STS-107 FLIGHT READINESS REVIEW

BACKUP INFORMATION

**PREVIOUS FLIGHT
ANOMALIES
BACKUP**

ORBITER ACTIVE THERMAL CONTROL SYSTEM (ATCS)

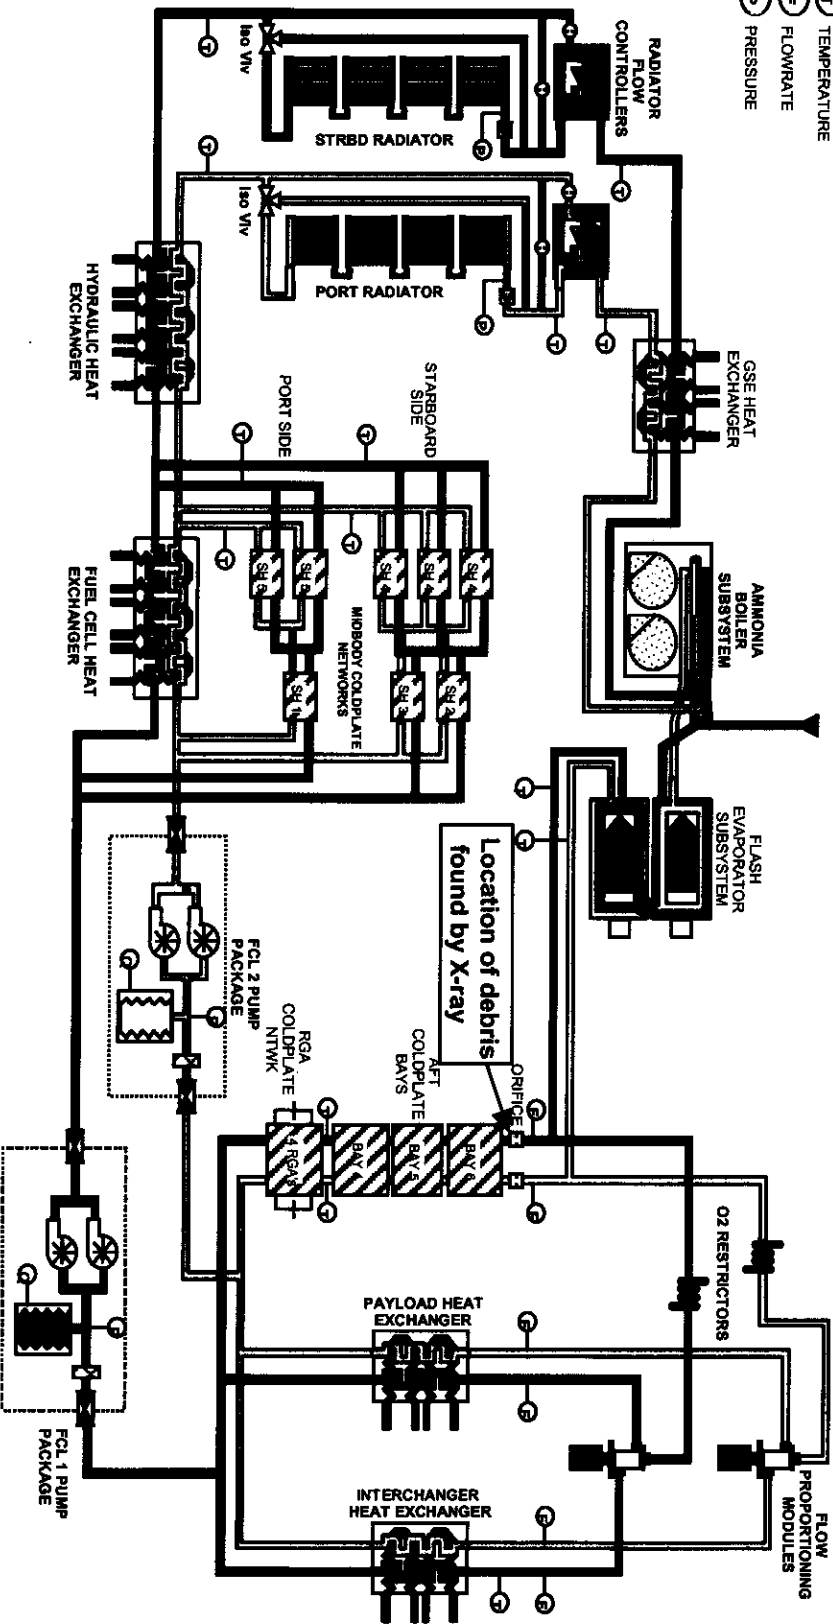
STS-109-V-01: FREON COOLANT LOOP 1 DEGRADED AFT COLD PLATE FLOW	
Presenter:	
Organization/Date:	Orbiter 01/09/03

- Freon coolant loop (FCL) 1 aft cold plate (ACP) flow dropped from 305 to 225 lbs/hr after MECO

- Flow rate reduction could result in loss of a FCL and early mission termination

- Approximately ten minutes after lift-off, the FCL 1 ACP flow rate dropped from 305 lbs/hr to 225 lbs/hr, then to 195 lbs/hr when the FCL was reconfigured to rad flow
 - Data review confirmed that the flow reduction was caused by a restriction in the ACP leg
- The flow rate stabilized, and analysis determined that adequate flow would still be available to provide sufficient cooling for the remainder of STS-109

- During post-flight troubleshooting, a piece of debris was found stuck in the upstream side of the orifice between the FES and the aft coldplate network
- FCL 1 was de-serviced and de-brazed to allow extraction of the contaminant
 - Laboratory analysis confirmed that segment of braze preform became detached during brazing
- More x-rays were taken at other suspected locations after power-down to ensure no additional FOD is present in either loop 1 or 2 (see next slides)
 - Included x-rays of three potential traps in the RFCAs
- Visual inspections of FCL 1 FPM & pump inlet filters were also performed
 - FPM 1 and pump inlet filters replaced

X-rayed Locations for Coldplate Network

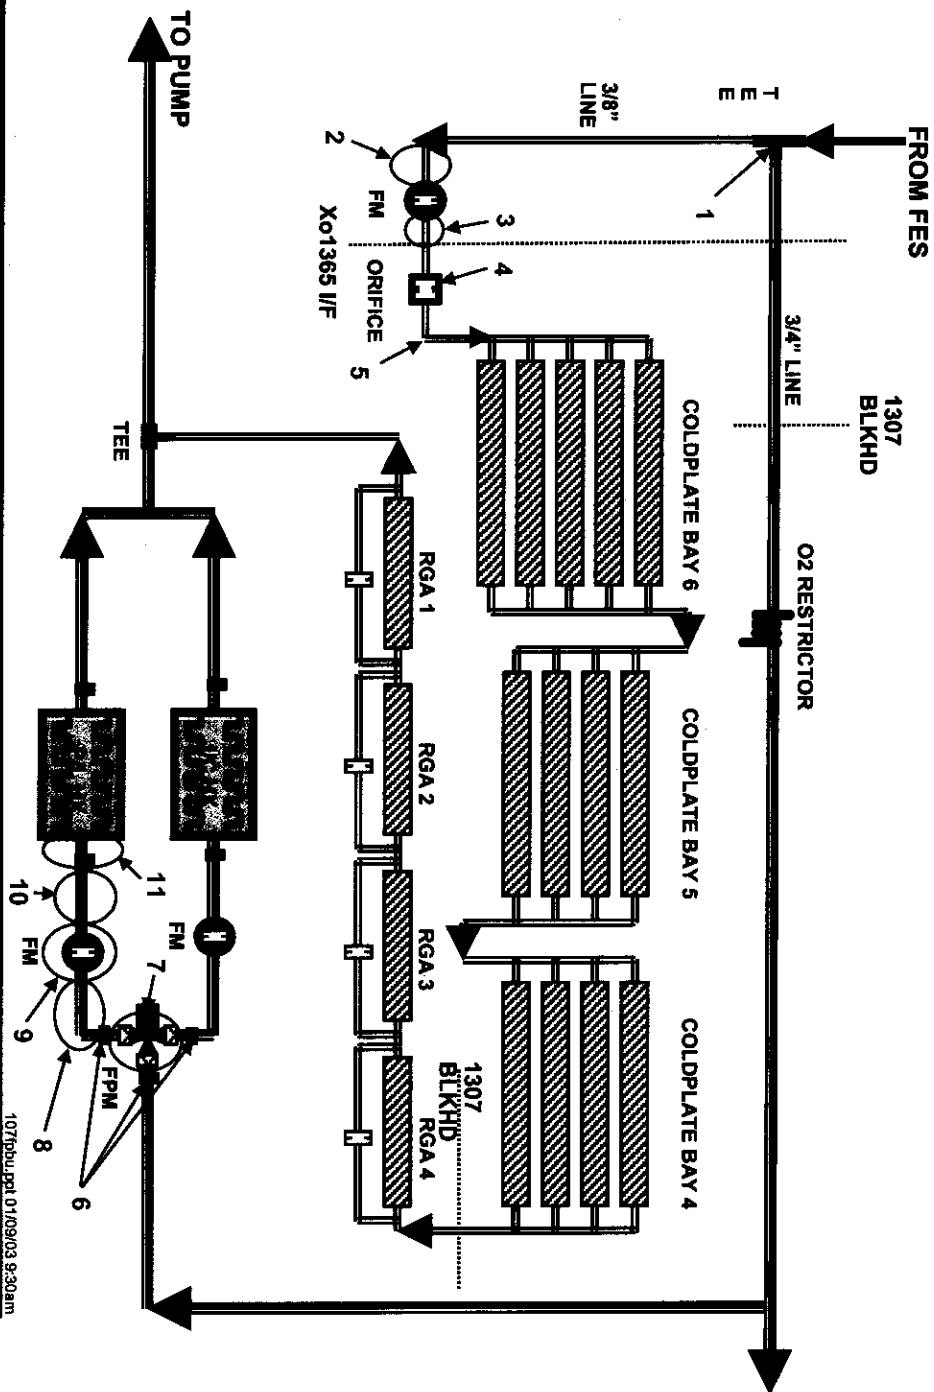
X-rayed Locations for Coldplate Network:

- 1 – 3/4" – 3/8" reducer tee
- 2 – Coldplate flow sensor inlet braze/180 deg inlet tube bend
- 3 – Coldplate flow sensor outlet braze/90 deg outlet bend to X_o1365 bulkhead
- 4 – Coldplate flow orifice (debris lodged here)
- 5 – Avionics bay 6 inlet tube (90 deg bend) [FCL 1 only]
- 6 – FPM (Flow Proportioning Module) inlet/outlet brazes
- 7 – FPM inlet/outlet filters (3 each)
- 8 – FPM outlet tube bend including entire line to P/L flow sensor inlet
- 9 – Payload flow sensor including inlet/outlet brazes
- 10 – Entire line from payload flow sensor to inlet of P/L HX
- 11 – P/L HX inlet header and braze

- The debris that caused the flow restriction was removed
- Additional x-rays taken at potential debris traps in both loops and visual inspection of FCL 1 FPM & pump inlet filters verified acceptable system cleanliness
 - FPM 1 and pump inlet filters replaced
- Freon systems have been verified through OMRSD testing

X-rayed Locations for FES, Radiator and RFCA

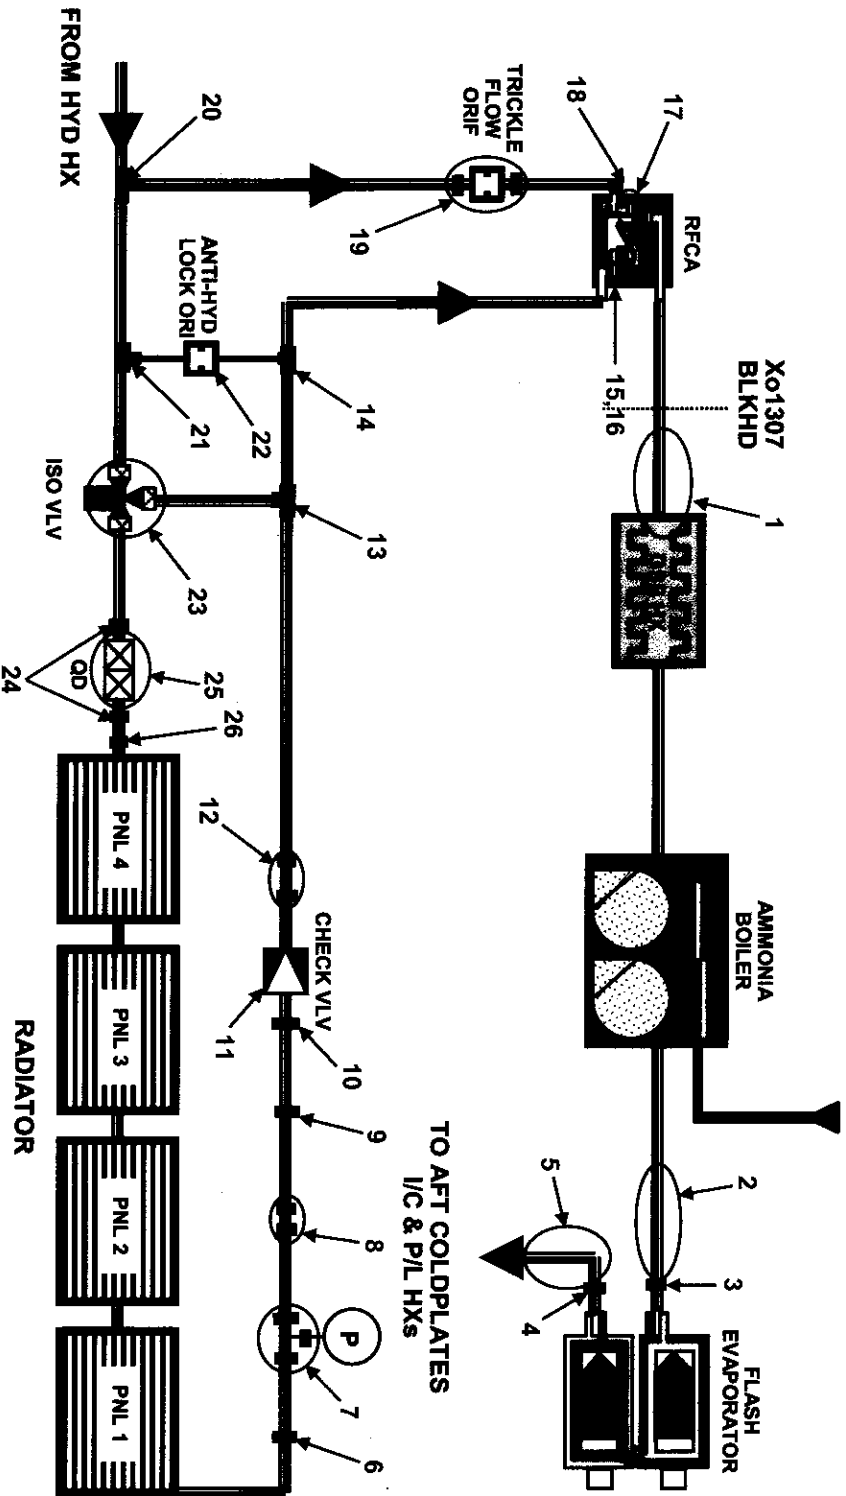
FCL 1 X-rayed Locations for FES, Radiator and RFCA:

- 1 – GSE HX inlet header/tube run upstream to 1st clamp
- 2 – FES inlet line from 1st line clamp upstream to inlet
braze
- 3 – FES inlet braze
- 4 – FES outlet braze
- 5 – FES outlet line down to 1st clamp (including
male/female mechanical fittings)
- 6 – Tube/tube braze
- 7 – Tee (3 brazes)
- 8 – Elbow to tube/flexline (2 brazes)
- 9 – Flexline braze to tube flange support
- 10 – Tube flange support outlet braze to dynatube braze
TP231B

X-rayed Locations for FES, Radiator and RFCA: (cont)

- 11 – Isolation check valve
 - 12 – Elbow brazes to check valve/tube*
 - 13 – Tee (3 brazes)*
 - 14 – Tee (2 brazes), brazed to item 13 tee*
 - 15 – RFCA flow control valve inlet filter (cold)
 - 16 – RFCA flow control valve inlet filter (hot)
 - 17 – RFCA bypass valve inlet filter
 - 18 – RFCA bypass leg inlet braze*
 - 19 – Bypass orifice including inlet/outlet brazes
 - 20 – Tee (3 brazes)*
 - 21 – Tee (2 brazes), brazed to item 20 tee
 - 22 – Anti-hydraulic lock up orifice*
 - 23 – Iso valve body and inlet/outlet brazes (3)
 - 24 – QD inlet braze at flexline interface/QD outlet braze*
 - 25 – QD interface male/female
 - 26 – Tube to tube braze*
- * Indicates FCL 1 only

STS-109-V-02: AIRLOCK A HATCH
LOCKING DEVICE DIFFICULT TO
ACTUATE

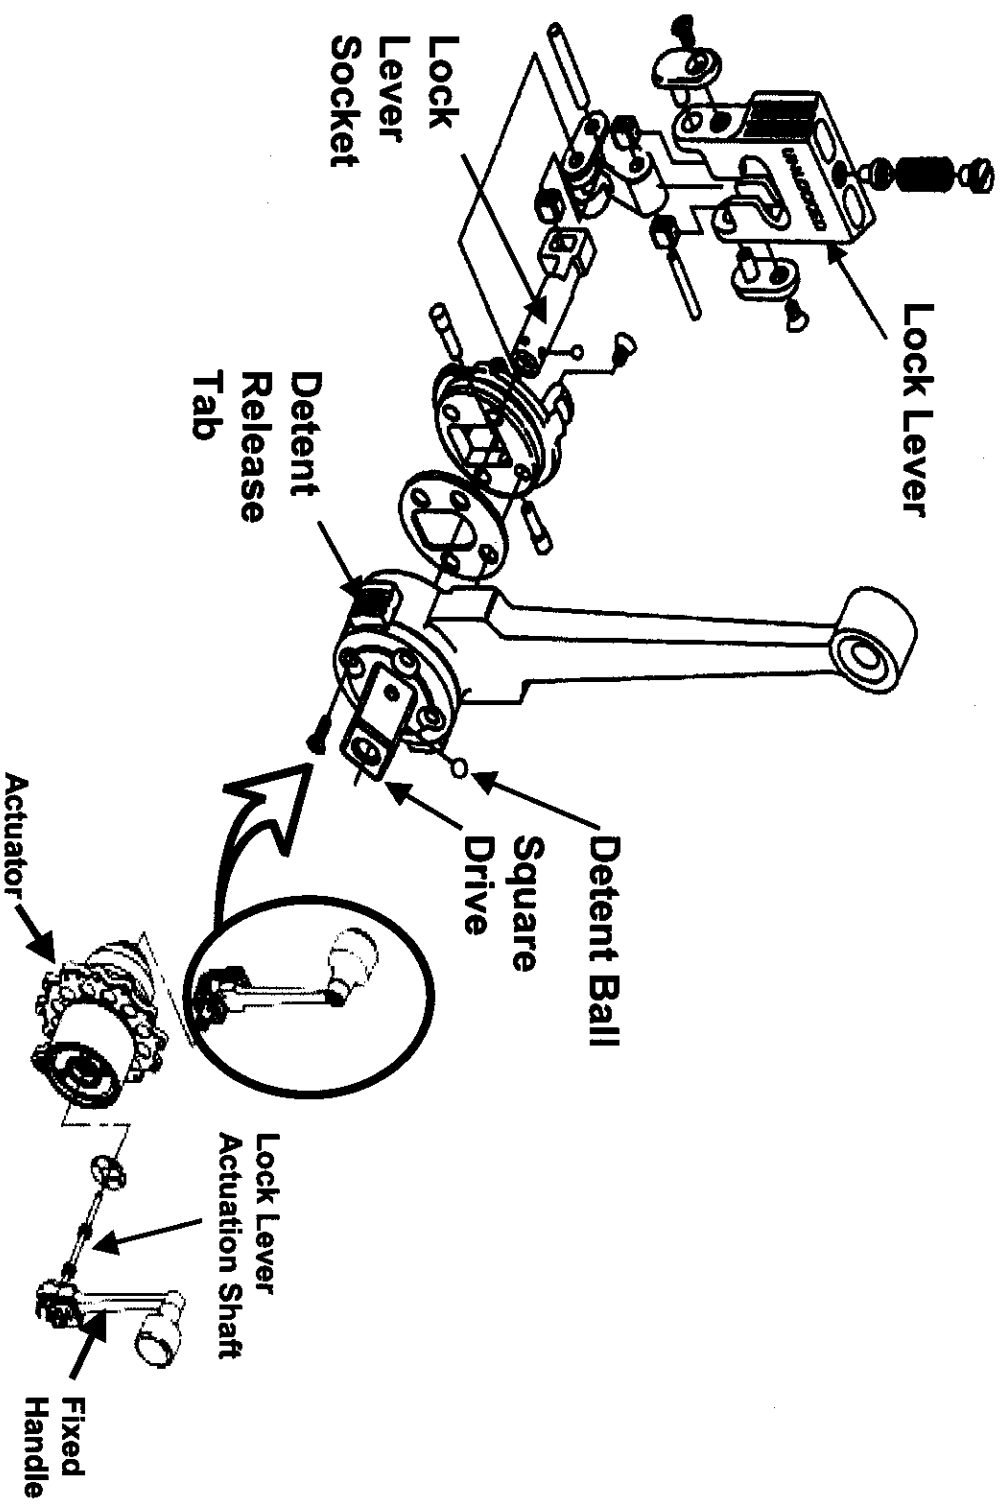
- When the crew first attempted to open the internal airlock "A" hatch during STS-109, they reported that the actuator would not unlock when the lock tab was moved to the unlocked position
- The crew noticed that the removable handle was partially disengaged from the actuator, so they reseated it and were then able to unlock and unlatch the hatch successfully

- Inability to unlock the hatch actuator prevents the crew from unlatching the hatch and entering the airlock for EVAs (crit 1R/2)

- The removable handle on the crew module side of this actuator must be fully seated in order for the lock lever socket to be properly engaged
 - With the handle unseated, lock lever can move separately from the rest of the lock mechanism
- During final hatch closeout for flight, handle was noted to be fully seated, and actuator functioned properly

- On-vehicle post-flight troubleshooting revealed that the actuator handle release tabs did not spring back after being depressed
 - Handle became unseated when lock lever was moved
- Removed the handle/actuator assembly and sent it to the NSLD for TT&E and repair

- Installed the spare assembly and successfully performed functional testing
- Will re-verify proper handle engagement after platforms are removed before launch
- Will consider adding permanent OMRSD requirement to verify proper handle engagement after platforms removed

STS-109-V-03: MPS 4-INCH
RECIRCULATION DISCONNECT
SLOW TO CLOSE

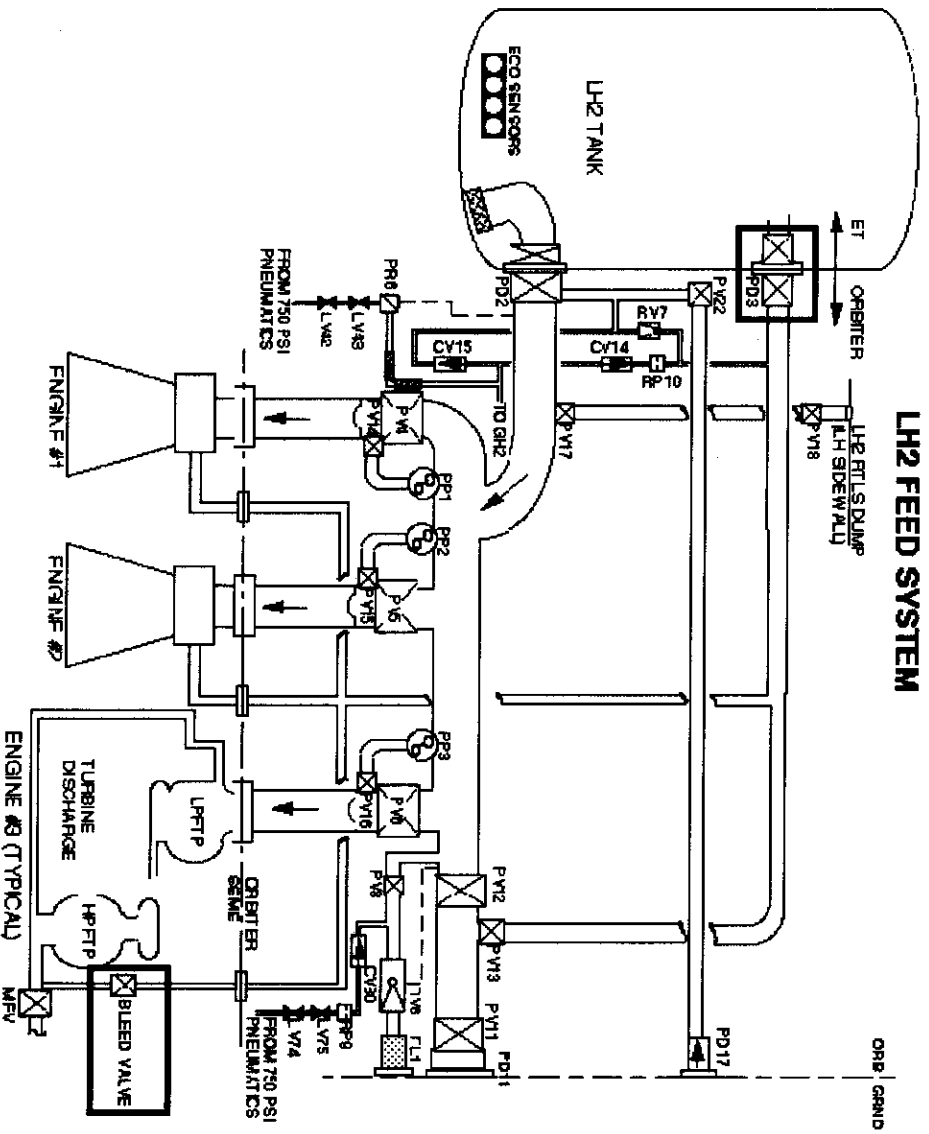
- MPS LH2 4" disconnect failed to close pneumatically when commanded at MECO
 - Closed via back-up mechanical mode at ET/Orbiter umbilical separation

- Failure of the 4" disconnect to close pneumatically in the case of a pre-MECO SSME shutdown or pad-abort results in inability to isolate the affected SSME from the hydrogen in the ET
 - No concern for nominal mission
 - Minor helium loss during entry if disconnect fails to close in back-up mechanical mode

- Inspection of Orbiter disconnect post-landing for indications of failure
 - Initial runway inspection revealed nothing unusual
 - Borescope inspection found Flourogold spacer (spool which negator spring slides/rotates on) cut and bent in towards springs
 - Scuff mark found on back of housing
- Disconnect R&R complete
 - Borescoped new disconnect and verified no damage
 - Leak checks complete and good
 - Removed PD3 failure analysis to follow
 - Ambient & cryo cycle tests

SUPPLY WATER SYSTEM

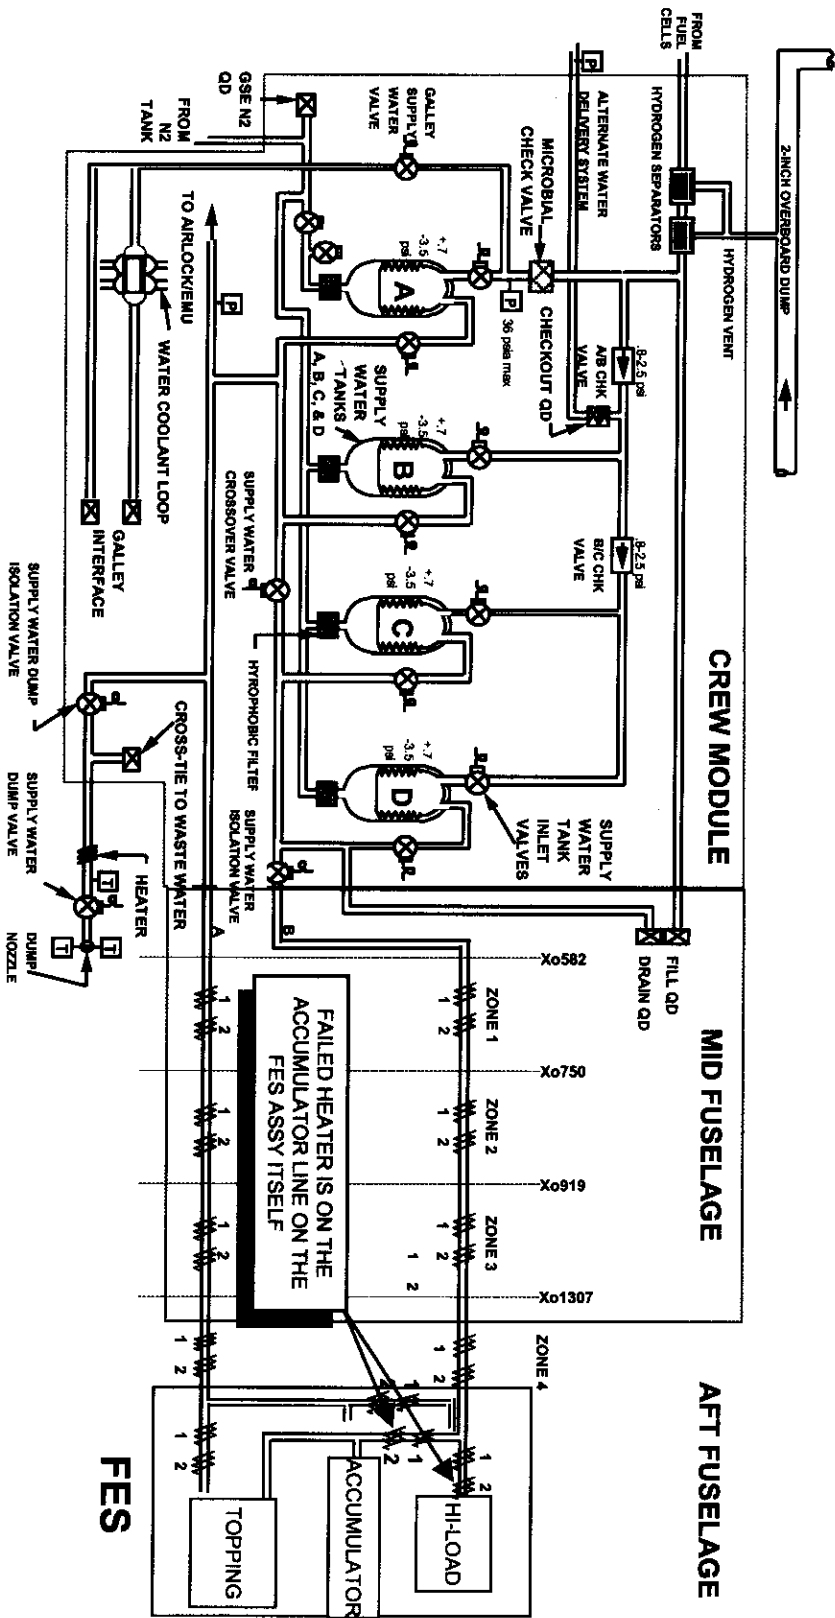
- FES accumulator/hi-load H₂O feedline B (starboard) heater system 2 zone 4 failed off

- Without corrective action, loss of a second heater may result in FES feedline freezing and potential loss of one of the FES water supply systems

- Accumulator line temperature (V63T1894A) and hi-load feed line temperature (V63T1896A) dropped to 50 °F & 60 °F respectively at MET 008:15:15 indicating a heater failure
- The crew switched to heater string 1 and the system performed nominally for the remainder of the mission

- Post-flight troubleshooting isolated the problem to a bad thermal switch
- Switch (S0V63S51) was replaced and successfully retested
- In addition, the feedline B accumulator line temp sensor (V63T1894A) was not responding during troubleshooting
 - Sensor was also replaced and successfully retested
